Re: Resubmittal of Well Abandonment Proposal

Redwood Coast Petroleum Bulk Fuel Facility

455 Yolanda Avenue, Santa Rosa, CA

Figure 2. Well Locations - Redwood Oil Bulk Plant, 455 Yolanda Avenue, Santa Rosa, California

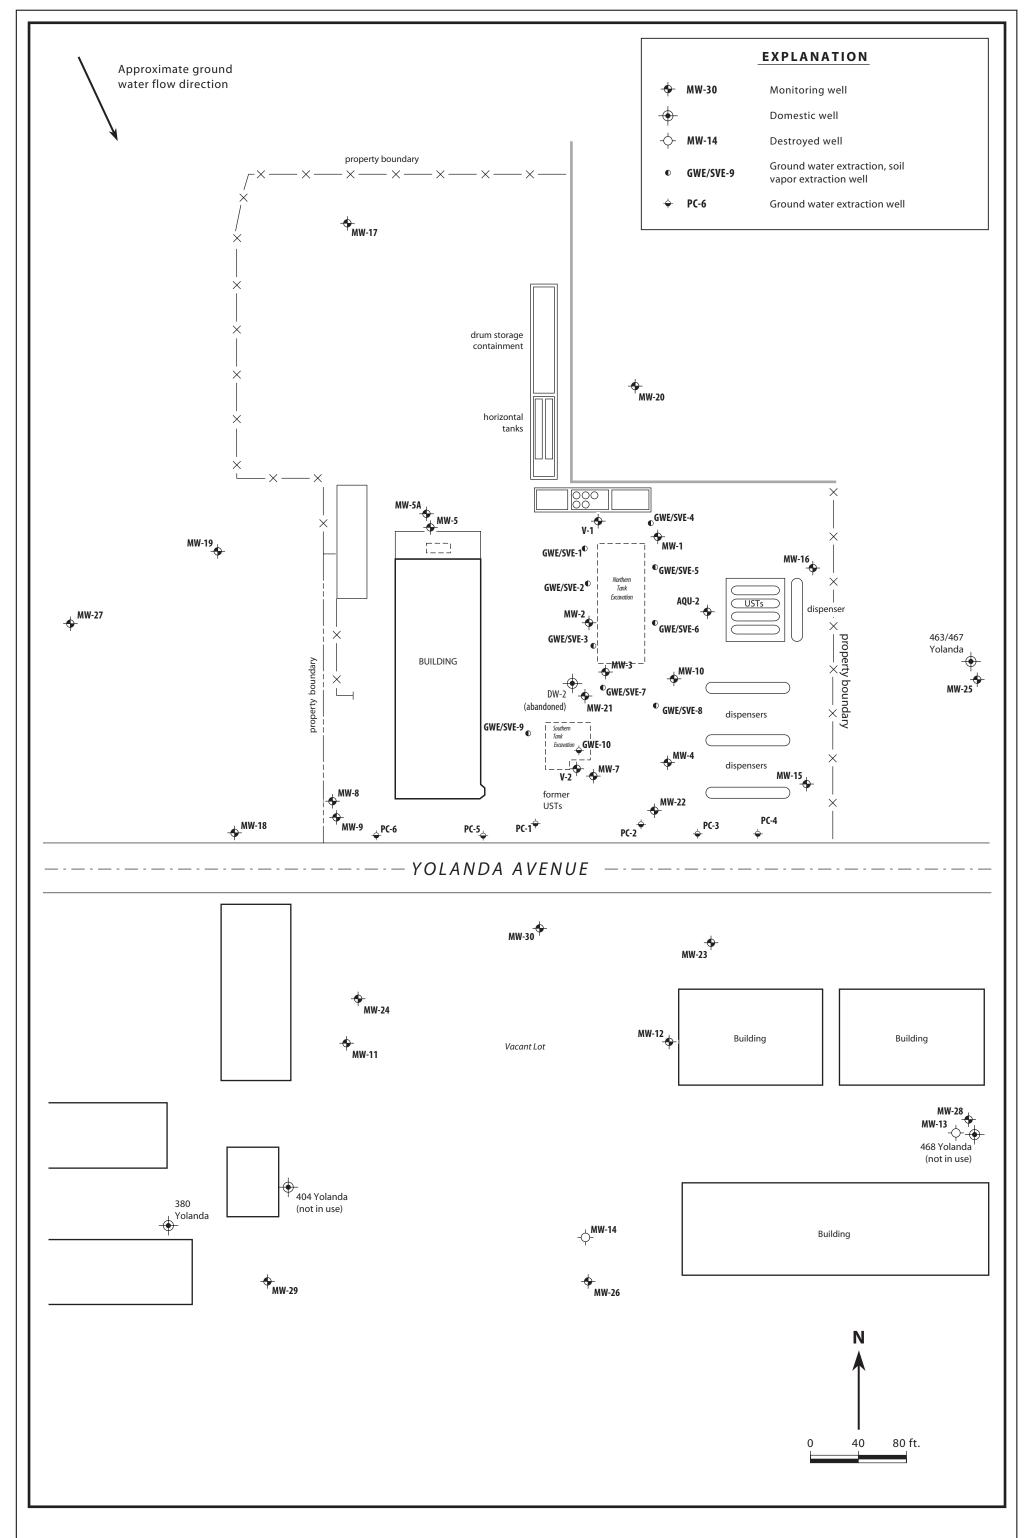
This letter has been prepared in response to your letter dated July 27, 2005 regarding the Feasibility Study Workplan - Corrective Action Plan, and the proposed well abandonment at the above referenced site (Figures 1 and 2, Appendix A). The letter states that MW-17, MW-18, and MW-19 may be abandoned at this time, but that none of the other wells proposed for abandonment may be decommissioned.

Well locations are shown in Figure 2, Appendix A. All wells proposed for abandonment were sampled in May 2005. Analytic results are submitted in Tables A and B (Appendix B).

ECM once again proposes that all the monitoring wells initially proposed for abandonment, with the exception of MW-5 and MW-5A, be abandoned. In addition to MW-17 through MW-18, this proposal includes the following wells:

MW-15 through MW-20 are all upgradient or crossgradient to the plume. It has been demonstrated that soil and groundwater has not been impacted in the area of these wells. The wells are not regularly sampled. Since abandonment is permitted for MW-17, MW-18, and MW-19, abandonment should also be permitted for MW-15, MW-16, and MW-20.

Neither MW-11 and MW-12 are needed for site characterization. MW-11 is located immediately adjacent to multi-level well MW-24. MW-12 is located near multi-level well MW-23. The wells are not regularly sampled, and it is proposed and recommended that they be abandoned.

(0.6 ppb) were detected. For the reasons given in the above paragraph, this does not justify the retention of V-1. It is proposed that V-1 be abandoned.

AQU-2 was originally installed to investigate the release at the Aquistapace site, which was located on what is now the eastern portion of the Redwood Oil Bulk Plant. The Aquistapace site was granted case closure several years ago, but monitoring well AQU-2 was retained at the direction of Board staff. AQU-2 has never been monitored under the monitoring plan for this site. There is no rationale for the continued retention of AQU-2. It is proposed AQU-2 be abandoned.

MW-27 and MW-25 are located crossgradient (east and west, respectively) of the plume. MW-27 and MW-29 are located downgradient in areas of minimal contamination. Oxygenates and BTEX constituents were detected at extremely low concentrations in a number of sampling ports in these wells during the May, 2005 sampling. These concentrations are minimal and not sufficient to warrant retention of the wells. The wells should be abandoned for the reasons given in the April 2005 well abandonment proposal. In summary:

ECM requests that the Board reconsider the proposal to abandon the above-listed wells. Thank you for your attention to this site. Please call if you have questions or require additional information.
